Planning Commission Regular Meeting | 5:30 PM

Wednesday, October 29, 2025

Final Plan Review for New Home

Hearing Date:	October 29, 2025
File Name and Process:	Single-Family Residence Final Plan Review
Owner/Applicant:	Clay & Becky Stevens
Representative:	Taylor Hermes & Rick Hermes, Minturn North Construction Company
Legal Description:	Subdivision: MINTURN NORTH PUD Lot: 1
Address:	0246 Miles End Lane
Zoning:	Game Creek Character Area – Minturn North PUD Zone District
Staff Member:	Madison Harris, Planner I
Recommendation:	Approval

Sheet No:
A2.1

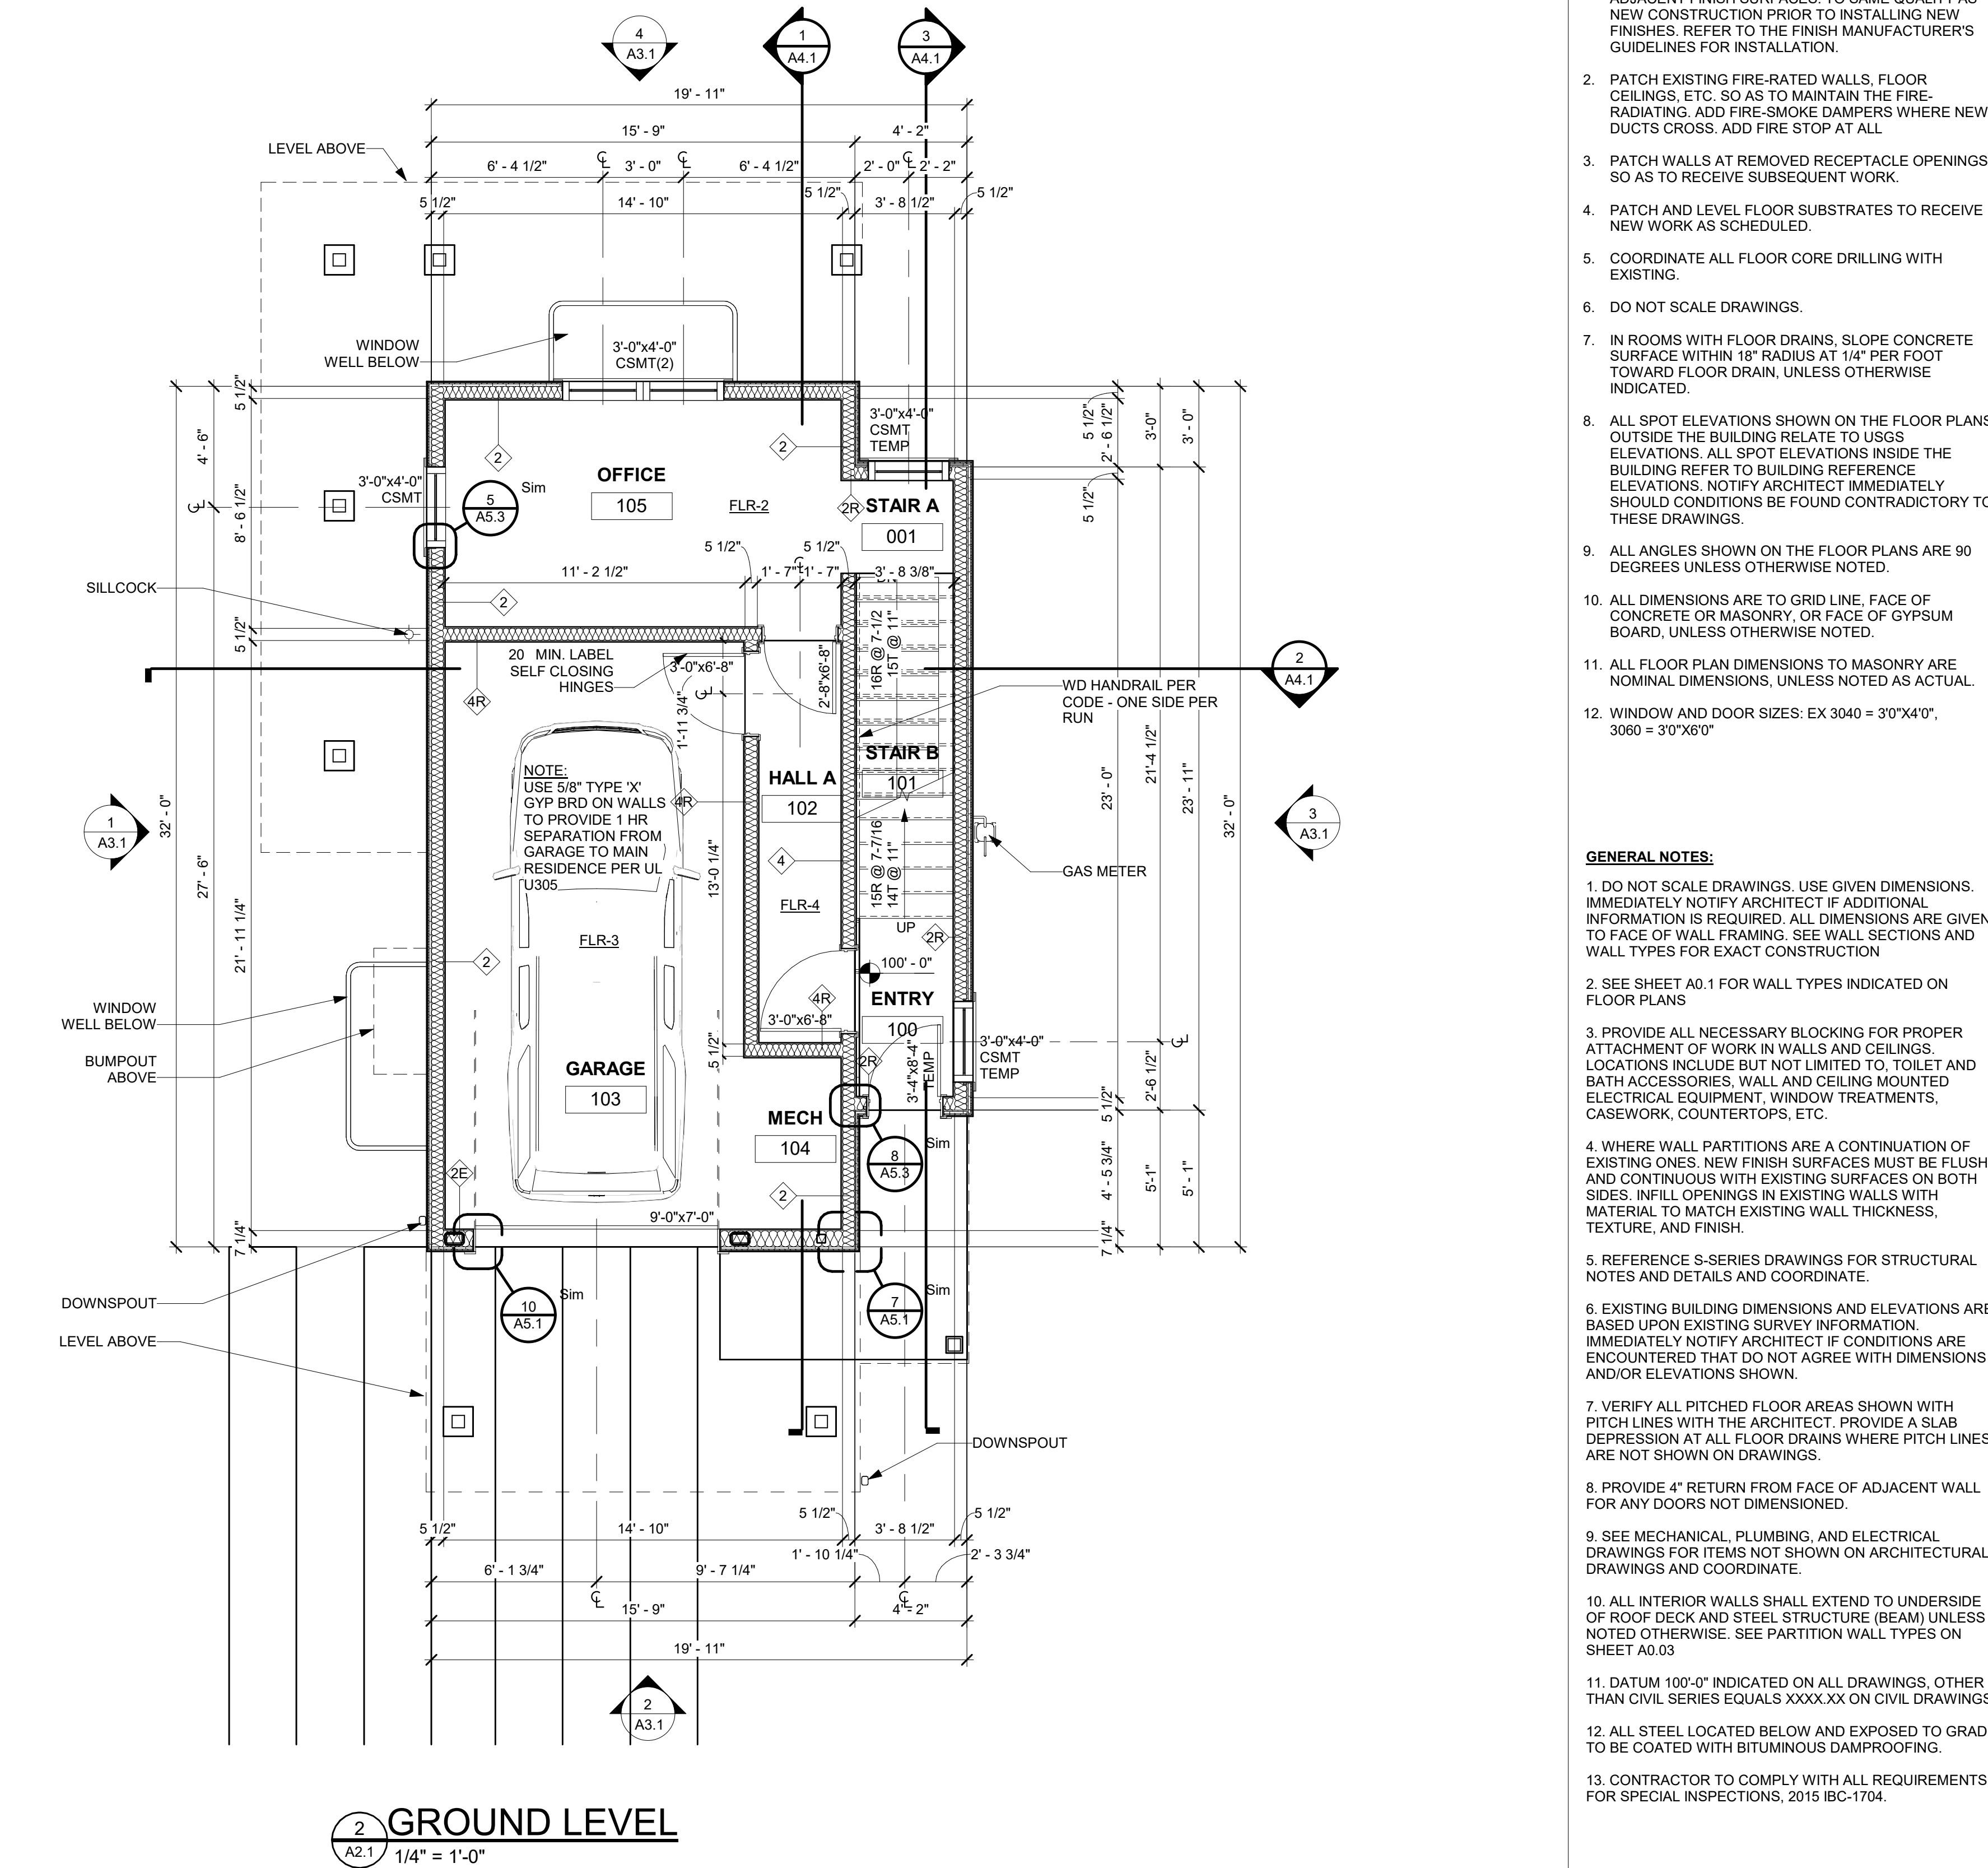
- M1. PLEASE PROVIDE THE REQUIRED MANUAL J AND S, M1401.2
M2. PLEASE PROVIDE THE REQUIRED MANUAL D, M1601.1
M3. PLEASE PROVIDE THE CONSTRUCTION DETAILS FOR THE PROPOSED WHOLE HOUSE VENTILATION SYSTEM, M1505.4
M4. SHEET A2.1: IF ALL THE GAS FIRED APPLIANCES ARE NOT SEALED COMBUSTION AND THE KITCHEN EXHAUST HOOD IS GREATER THAN 400 CFM MAKEUP AIR SYSTEM WILL BE REQUIRED. PLEASE PROVIDE THE CONSTRUCTION DETAILS FOR THE PROPOSED MAKEUP AIR SYSTEM IF NEEDED.

- P1. SHEET A2.1: LOWER FLOOR. PLEASE INDICATE HOW THE WATER HEATER AND ASSOCIATED PIPING WILL BE PROTECTED FROM FREEZING, P2603.5
PLEASE INDICATE THE REQUIRED 3' X 3' X 7' HIGH CLEAR SPACE AT THE WATER HEATER, R403.5.4 AS AMENDED
B. INDICATE THE REQUIRED CONDENSATE DRAIN AT THE WATER HEATER THAT WILL ALLOW NATURAL DRAINAGE, R403.5.4 AS AMENDED
PLEASE NOTE THAT THAT THESE TWO COMMENTS ARE INTENDED TO PROVIDE SPACE AND DRAINAGE FOR A HEAT PUMP WATER HEATER. WE ARE NOT AWARE THAT HEAT PUMP WATER HEATERS CAN BE INSTALLED IN AN UNCONDITIONED OR CONDITIONED GARAGE.
